SUBJECT: **Request for Modification of the Section 404 Individual Permit, Section 401 Water Quality Certification, Isolated Waters State General Permit, and Neuse River Riparian Buffer Certification** for the proposed East End Connector from NC 147 (Durham Freeway/Buck Dean Expressway) to north of NC 98 (Holloway Street) in Durham, Durham County, North Carolina, Division 5. Federal Aid Project No. NHF-76-1(2), TIP No. U-0071.

The purpose of this letter is to request a modification to the United States Army Corps of Engineers (USACE) Section 404 Individual Permit and North Carolina Division of Water Resources (NCDWR) Section 401 Water Quality Certification, Isolated Waters State General Permit, and Neuse River Riparian Buffer Certification for the above-referenced project.

In addition to this cover letter, please find enclosed revised Wetland Permit Drawing Sheet Nos. 30, 53, 55, 60, 90, and 91 of 91; revised Buffer Permit Drawing Sheet Nos. 6, 16, and 18 of 18; new ABF Freight Wetland Permit Drawing Sheet Nos. 1 and 2 of 2 for new Site No. 33, which is associated with the loss of property remediation between the N.C. Department of Transportation (NCDOT) and ABF Freight Corporatio

ABF Freight
Permit Drawing
Sheet 1 of 2
Added April 2016

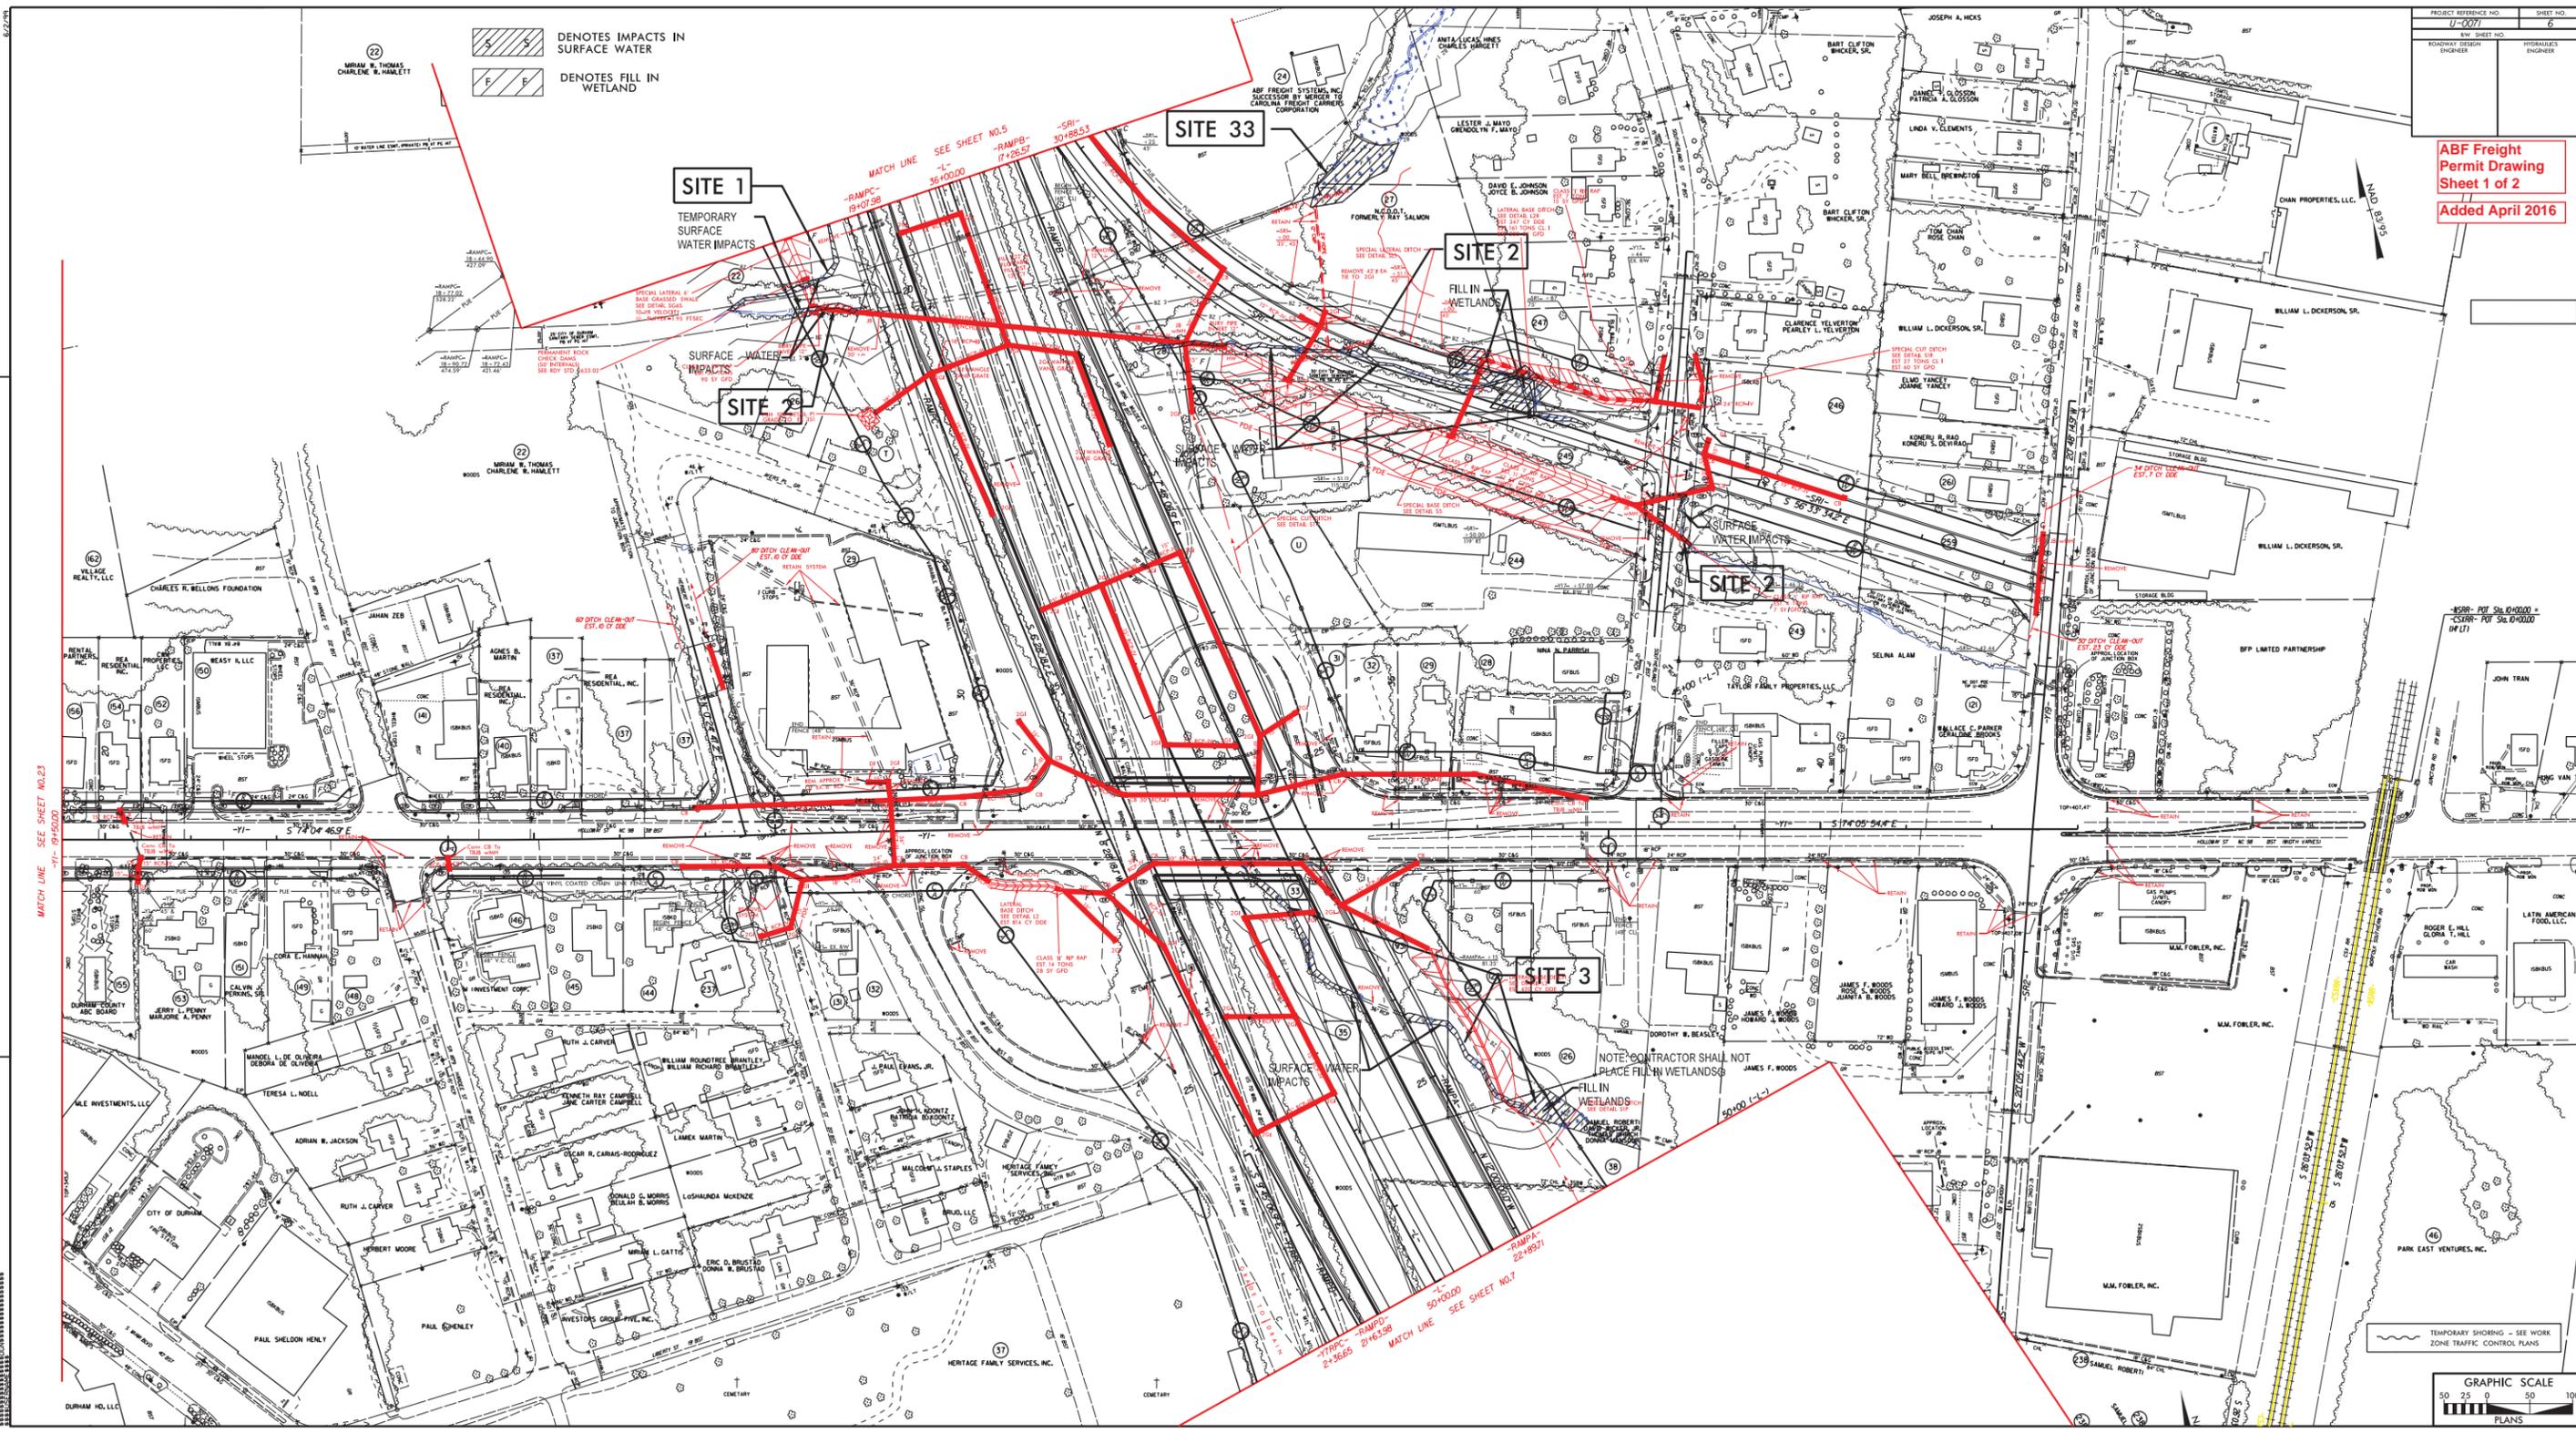
Permit Site 33

- ABF Freight Corporation, Horvath Associates (representing ABF Freight), and NCDOT have been working on a plan to remediate the loss of property resulting from TIP Project No. U-0071 on the ABF Freight parcel located at 208 Muldee Street in Durham, North Carolina. The remediation plan consists of replacing the lost truck terminal parking spaces and necessary truck turning movement area (which were lost due to NCDOT ROW encroachment) on an adjacent property. This property will remain outside of the limits of the NCDOT ROW upon completion of U-0071. Within the proposed limits of disturbance for the proposed work, there is a small portion of a jurisdictional

wetland (Wetland WA) that needs to be impacted in order for the replacement parking areas to reasonably function for the intended uses. Additionally, for proper truck movements to occur and for the replacement area to be used as needed by the ABF Freight Corporation, the disturbance of this wetland area is unavoidable. A large portion of this wetland will remain undisturbed and this request is only for disturbance of the area necessary for the site to function properly.

- This design addition will result in 0.09 ac. of permanent fill at Site No. 33.
